SERVICE BULLETIN

Service Bulletin No.: DAC1-24-05 Rev 1

Title: DA20 C1 – B & C Battery Retrofit

Figure 1

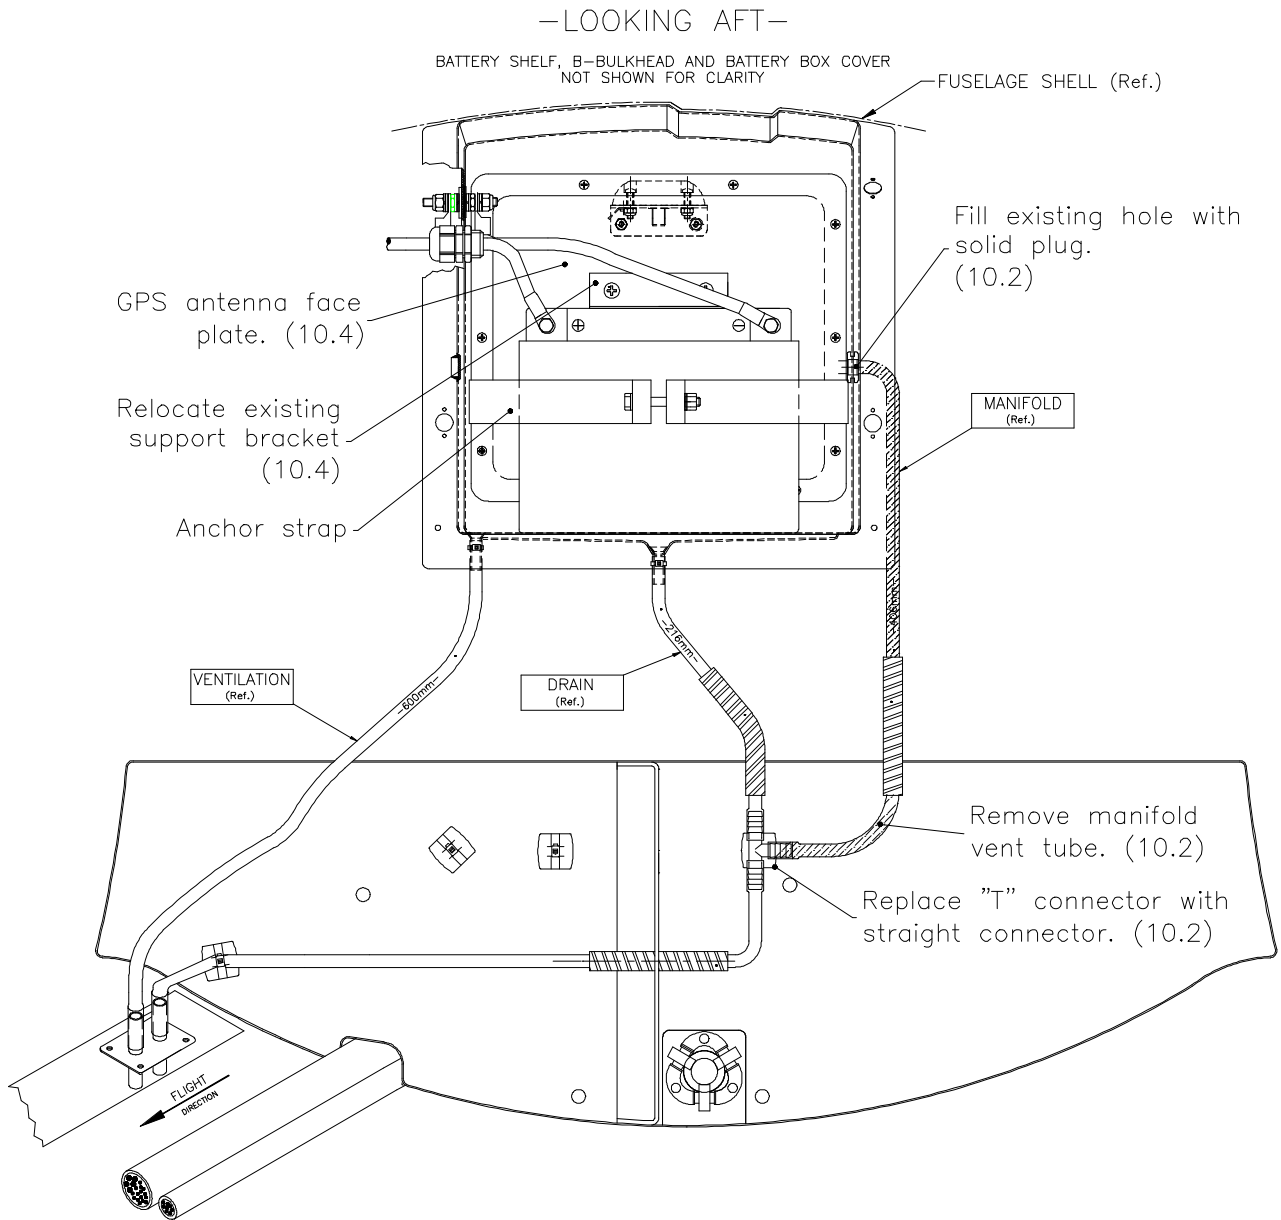
8. **Special Tools:** N/A
9. **References:** DA20-C1 Maintenance Manual (MM), Document # DA201-C1.
DA20-C1 Airplane Flight Manual (AFM), Document # DA202-C1.
10. **Accomplishment Instructions:**
 - 10.1 Remove the Yuasa battery in accordance with section 24-31-00 of the DA20-C1 Maintenance Manual.
 - 10.2 Remove the baggage floor. Remove the battery manifold overboard drain tube and replace the "T" tube connector (ty-wrapped to half-ring bulkhead) with the straight connector (0706-015). Plug hole in battery compartment with plug 245-005 (Reference Figure 1).

- 10.3** Place B & C battery on the battery shelf and push it all the way aft. The terminals point toward the front of aircraft.
